| Well Name: NAGEEZI             | Well Location: T24N / R9W / SEC 33 / SESW / 36.266174 / -107.797546 | County or Parish/State: SAN JUAN / NM |

Notice of Intent

| Type of Submission: Notice of Intent           | Type of Action: Plug and Abandonment |

## CONDITIONS OF APPROVAL

**Planned P & A Schematic**

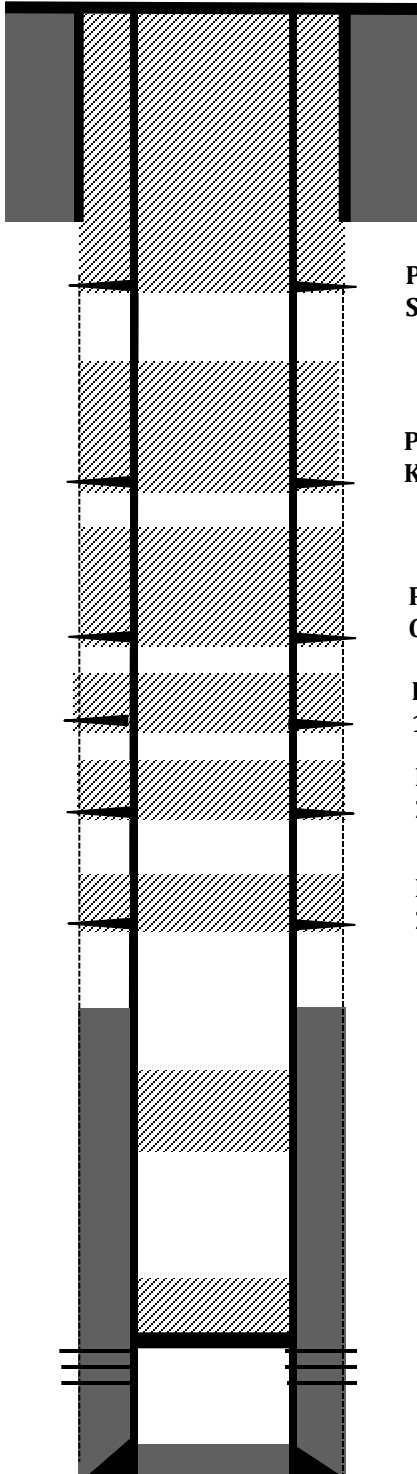
- a. Adjust Plug 3 (Mesaverde) to cover BLM geologist's Mesaverde formation top pick @ 2630'. Plug 3 should cover at a minimum 2530' - 2680'. If plug is tagged, the tag must be at 2560' or higher.

- b. Adjust Plug 5 (Upper Chacra) to cover BLM geologist's Upper Chacra formation top pick @ 1845'. Plug 5 should cover at a minimum 1745' – 1895'. If plug is tagged, the tag must be at 1775' or higher.

**Remarks:** Adjust plug V for BLM-Picked upper Chacra Formation. Adjust Plug III to cover BLM-picked Cliffhouse formation.

| Created By | Condition                                                                                                                                                                                                    | Condition Date |
|------------|--------------------------------------------------------------------------------------------------------------------------------------------------------------------------------------------------------------|----------------|
| mkuehling  | NMOCD agrees with BLM call on formation tops and adjustments to plugs - Notify NMOCD 24 hours prior to moving on - Monitor string pressures daily report on subsequent - submit all logs prior to subsequent | 1/27/2025      |
